**Flood Control Project Maintenance
Levee Inspections**

Fall 2018 Levee Maintenance Deficiency Summary Report

San Joaquin River Basin

Reclamation District No. 1602 Del Puerto

Photo 1 of 3 : UCIP_FA_2018_53523_76534.jpg

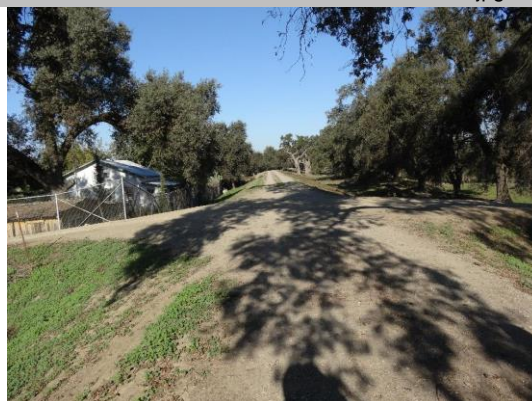
UCIP Comments: 10/19/2018 Pipe section through the WS ramp was exposed during the 2017 storms. According to LMA representative, adjacent property owner has backfilled the pipe with soil to avoid damage to line. Contacted Mr. Chris Williams with PG&E and Mr. Williams mentioned that PG&E is planning to abandon the line and install a new line. The new line will be bored through the levee. Mr. Williams also mentioned that the line was inspected in 2016-17 and was found to be functional. However, due to the pipe exposure in 2017 PG&E has decided to abandon the current line. PG&E is working with the CVFPB to obtain the proper permits and complete the final design for the new line. This crossing has been downgraded from Urgent to Non-Urgent due to the updated UCIP reclassification evaluations. Pending action for this crossing includes line abandonment documentation from CVFPB and closeout files for this crossing. Primary PG&E contact for this crossing is Carlos Carbrera, Stanislaus and San Joaquin PG&E Local Engineer. He can be reached at 1-925-789-0509 or by email at c4ch@pge.com. (O. Magana - DWR UCIP)11/18/2016 Same as previous inspection crossing is missing markers visible from levee crown. PG&E completed some construction work on this line from September - November 3rd, 2016 and installed a marker on WS approximately 341 feet from levee crown. UCIP inspector will need to contact Mr. Chris Williams, Associate Construction Specialist, Gas Construction Management Central Valley Region with PG&E at 1-209-272-2811 to determine extent of inspection through levee. (O. Magana - DWR UCIP)10/01/2013 Gasline needs sign markers at levee. (W. Wylie - DWR UCIP)
